# CITY OF ALBUQUERQUE

**RE: Lot 8 Block 2 Unser Cliffs SAD 227  
6704 Rim Rock Circ. NW  
Grading and Drainage Plan  
Engineers Stamp Date 3/25/2023 (D10D025)**

<b>6704 RIM ROCK CIR NW GRADING PLAN</b>			
DRAWING: RIM ROCK GD.dwg	DRAWN BY: SH-B	DATE: 3/25/2023	SHEET # <b>1</b>

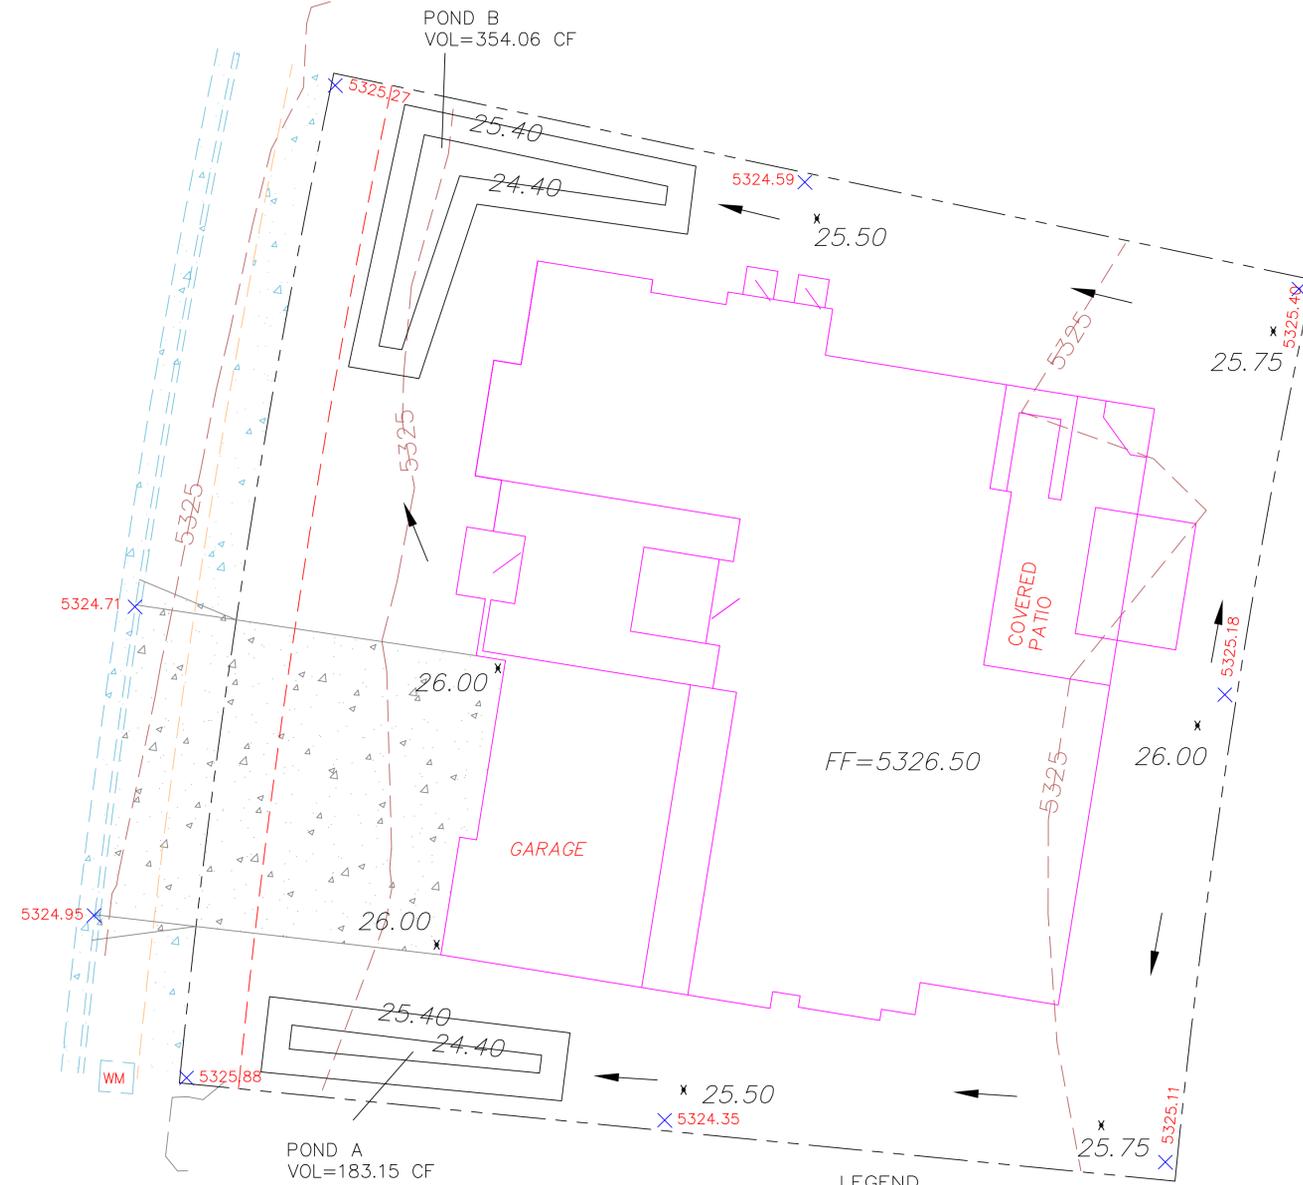
- The building pad cannot be higher than 1 foot above the road elevation, unless there is a reason given on the plan as to why it must be higher than 1 foot.
- Provide a table of land treatments for existing and proposed.
